## Agenda Item # 2

### SUB-002908-2024

1451 Butler Street

Janice Lynum Subdivision

## DETAIL SITE PLAN

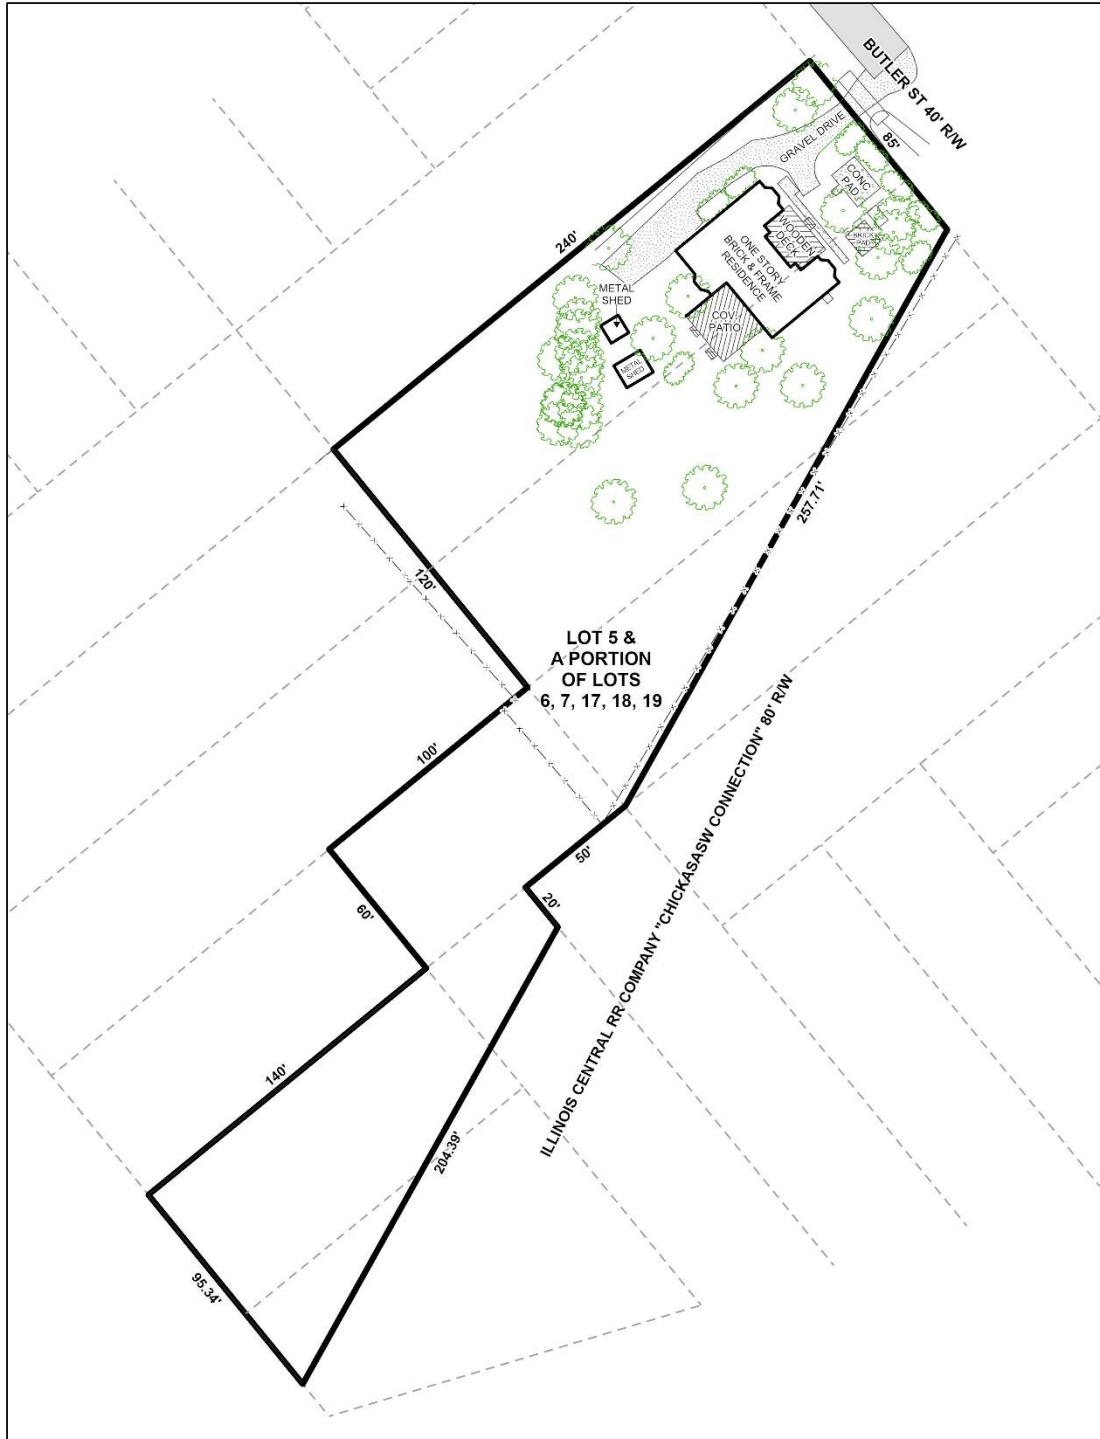
No plat was submitted as part of the request, but staff utilized the survey provided by the applicant to determine the site's compatibility with the Subdivision Regulations. A subdivision plat will be required for final approval of the request, per Section 5.A.

The proposed lot is a double frontage lot with frontage along both Butler Street and Katye Street. Butler Street is a minor street without curb and gutter requiring a 60-foot right-of-way width, while Katye Street is a minor street with curb and gutter requiring a 50-foot right-of-way width. The survey does not depict Katye Street and illustrates a 40-foot right-of-way (ROW) for Butler Street. If approved, the Final Plat should be revised to illustrate Katye Street with compliant ROW and dedication sufficient to provide 30 feet from the centerline of Butler Street. Should existing ROW for Katye Street be insufficient to comply with the 50-foot required of a minor street with curb and gutter, dedication sufficient to provide 25 feet from the centerline of Katye Street should also be illustrated on the Final Plat.

The lot, as proposed, exceeds the minimum size requirements for lots served by public water and sanitary sewer in an R-1, Single-Family Residential Urban District. Its size, however, is not labeled in either square feet or acres, as required by Section 5.A.2(e)(4) of the Subdivision Regulations. If approved, the size of the lot in both square feet and acres, adjusted for any required dedication, should be labeled on the Final Plat; or provision of a table on the Final Plat with the same information will suffice.

The survey does not depict a minimum building setback line on either frontage. A minimum 5-foot front yard setback is required along all frontages, in compliance with Article 2 Section 64-2-5.E. of the Unified Development

Code for lots zoned R-1 in the Urban sub-district. If approved, the Final Plat should be revised to illustrate a compliant setback along all frontages; again, adjusted for any required dedication.

The site exceeds the maximum width-to-depth ratio of 3.5 times allowed under the Subdivision Regulations. As such, if approved, a waiver of Section 6.C.3 would be necessary. Additionally, the survey depicts the proposed lot as an irregularly shaped lot. Per Section 6.C.1 of the Subdivision Regulations, the size, shape, and orientation of lots should be compatible and appropriate with the location of the subdivision and the type of development and use contemplated. It appears the parcel has been used in its current configuration for some time; as such, if approved, a waiver of Section 6.C.1 may be appropriate.

1. Provision of a subdivision plat in compliance with Section 5.A. of the Subdivision Regulations;
2. Revision of the Final Plat to illustrate Katye Street with compliant right-of-way and/or dedication sufficient to provide 25 feet from the centerline of Katye Street;

3. Provision of dedication sufficient to provide 30 feet from the centerline of Butler Street;
4. Provision of a label with the lot's size in both square feet and acres, or provision of a table on the Final Plat providing the same information, adjusted for dedication;

5. Revision of the Final Plat to illustrate a minimum 5-foot front yard setback along all frontages, in compliance with Article 2 Section 64-2-5.E. of the Unified Development Code for lots zoned R-1 in the Urban sub-district, adjusted for any required dedication;
